Restroom Accessibility Tour Notes

17th floor holding cell

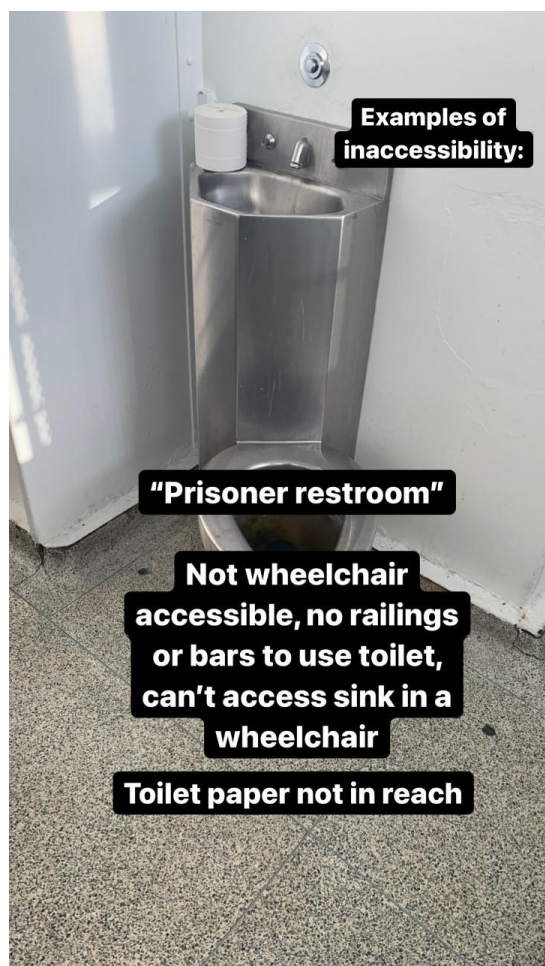
Image description: small restroom in holding cell for inmates awaiting court or transfer. The text refers to this as a "prisoner restroom" (language used by officer), not wheelchair accessible, no railings or bars, can't access sink in a wheelchair or other mobility device, toilet paper not in reach for accessibility needs.

No accessible restroom on 17th Floor:

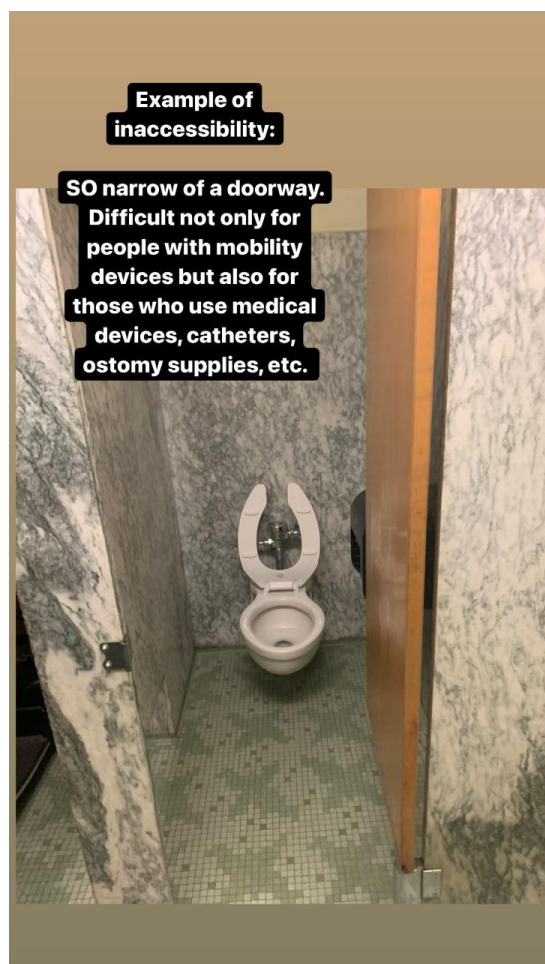
- Image description: bathroom stalls with arrows indicating how narrow the stalls are. Text examples of inaccessibility included, "No disability-accessible stalls (no wheelchair accessible, no ambulatory accessible), extremely narrow doorways, two heavy doors close together to gain access to the restroom, not wide enough to maneuver to back out and leave restroom independently in a wheelchair, soap and dispensers out of reach."
- Inability to reach soap and toilet-seat covers if in a wheelchair
- No door openers

Restroom on 15th

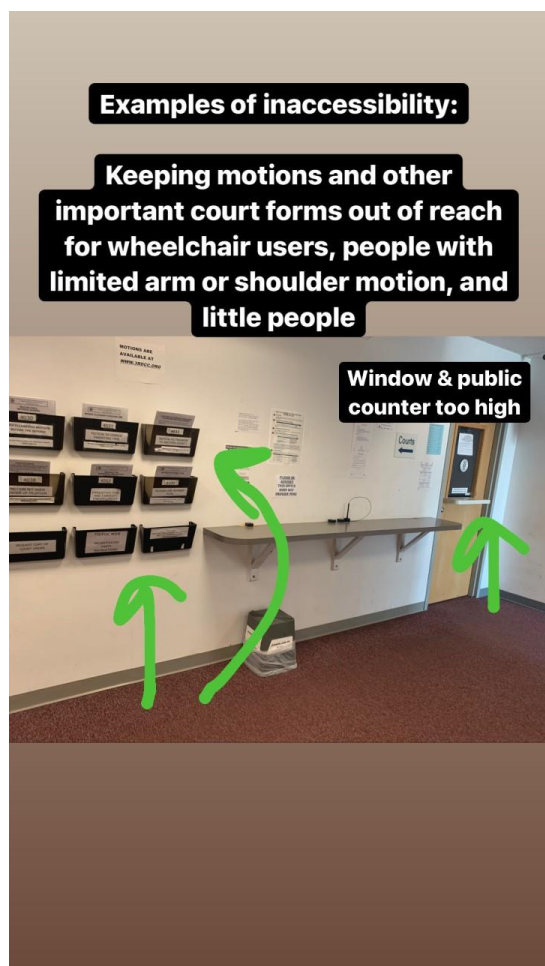
- can't maneuver chair to get out independently
- Similar issues as on 17th floor
- No accessible urinals

Hallway Access to Legal Documents, Counters:

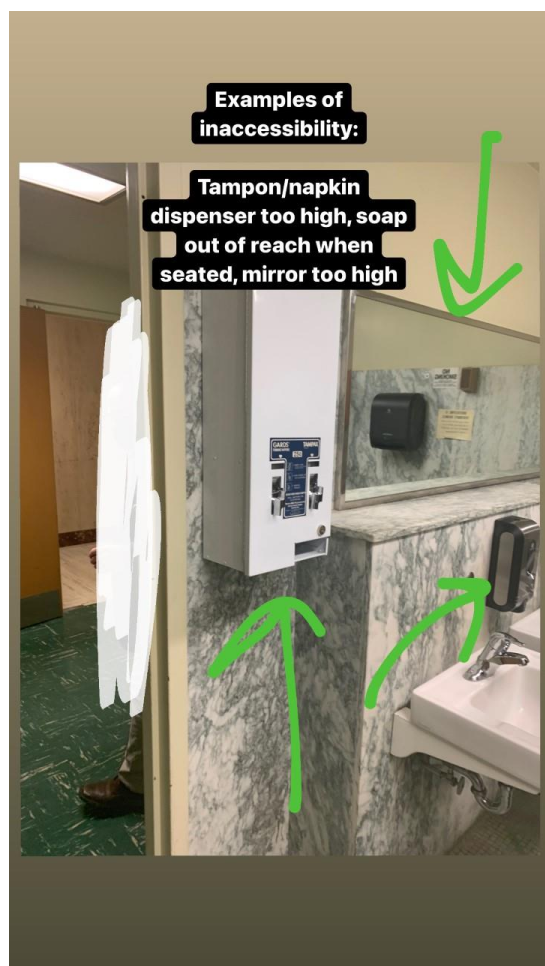
- Image description: a hallway with counters to complete and exchange documents, and document holders on the wall holding several legal document forms. Text added reads, "Keeping motions and other important court forms out of reach for wheelchair users, people with limited arm or shoulder motion, and little people."

ADA bathroom (I believe on the 9th floor)

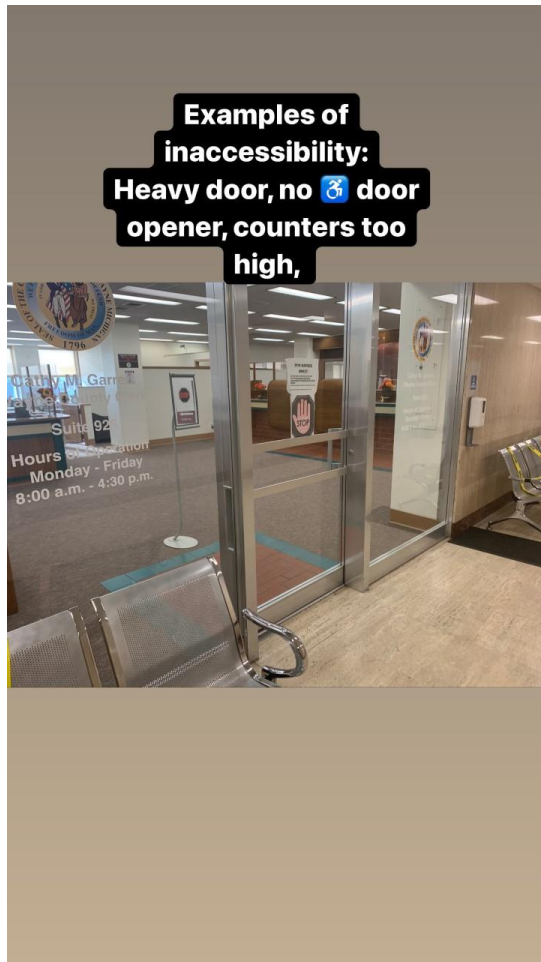
- Image description: a picture of a doorway with tampon/napkin dispenser and sinks in view. Text added reads, "tampon/napkin dispenser too high, soap out of reach when seated, mirror too high."

Clerk's office

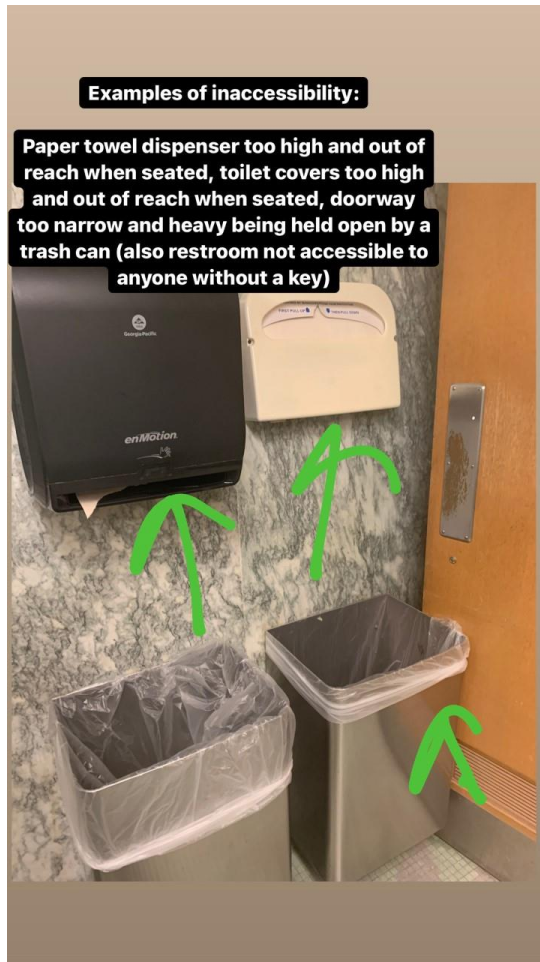
- Image description: The glass door and windows to the clerk's office, showing counters. Text added reads, "heavy door, no door opener, counters too high."

- Image description: image of a heavy doorway into the clerk's office, which is heavy, no door opener
